**PLANNING PERMIT APPLICATION PA2016/5118 AND
WORKS APPROVAL APPLICATION 1002191 –
EXTENSION TO THE LANDFILL AT 408-546 HOPKINS ROAD,
TRUGANINA AND 1154-1198 CHRISTIES ROAD, RAVENHALL**
Submission by Melton City Council, 11 July 2016

Melton City Council Submission, 11 July 2016

5.3 Buffer Plan

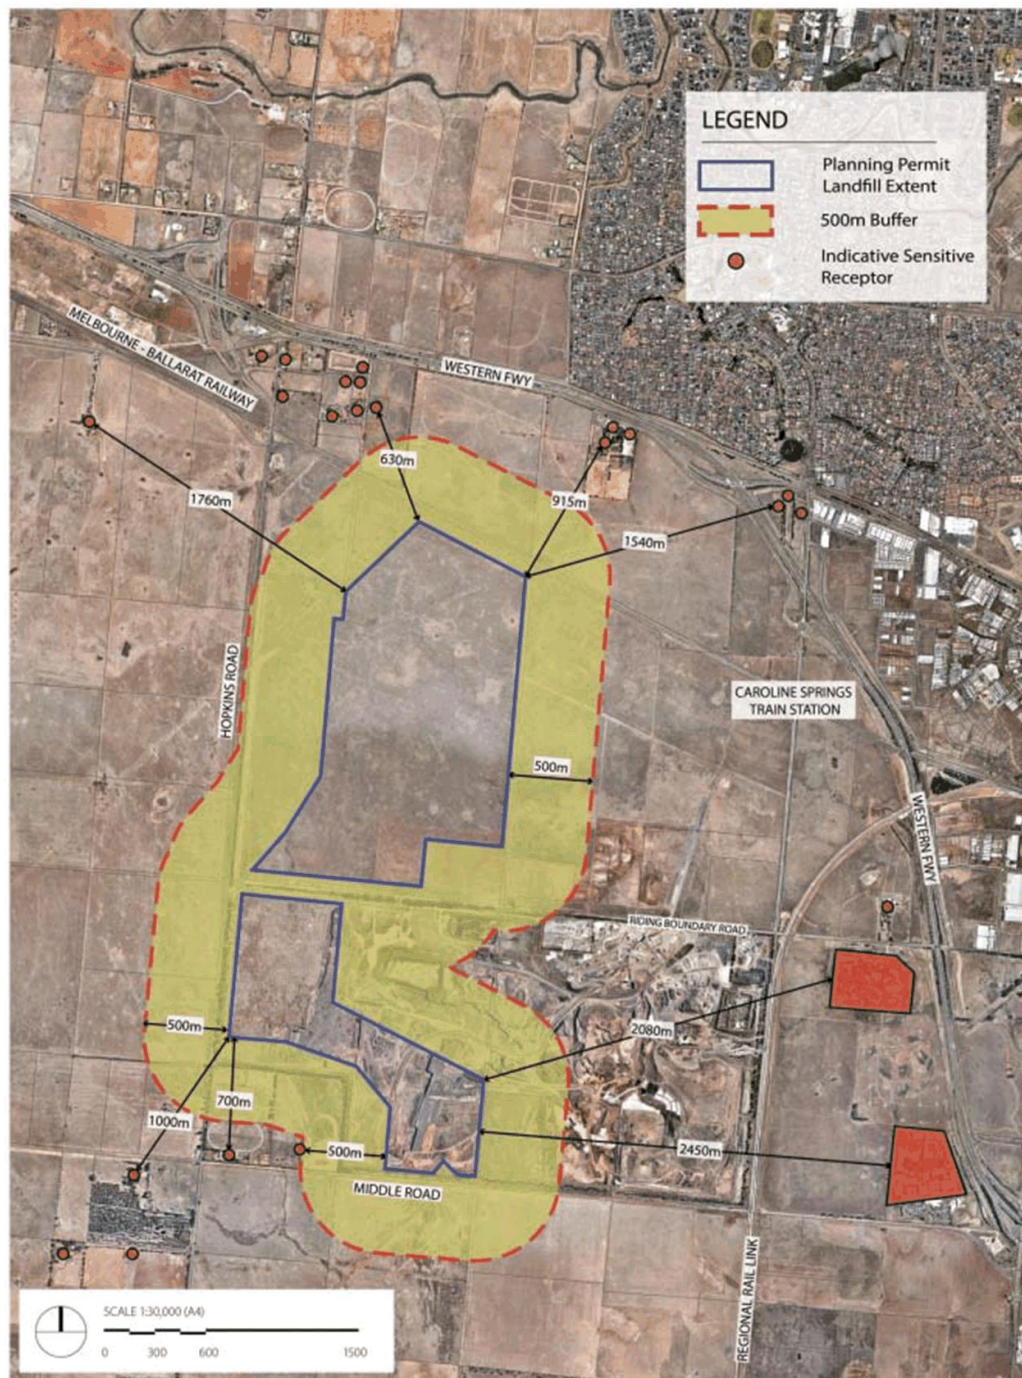
Given the complexities of the proposal, it is Council's view that the buffers which affect the PSP area should be moved to be located entirely on the landfill site. This would require a boundary change to the cells proposed as part of the Applications.

Council does not agree with the MPA's assumptions regarding landfill gas migration within the PSP. MPA has formed the opinion that landfill gas migration will be managed entirely on the landfill site. Given no decision has been made on the Permit Application, and given the Applications have not been through a consultation process, Council submits the MPA should not assume that this is the case and should at least recognise the potential for landfill gas within the PSP, and put in place planning controls to manage the associated risk.
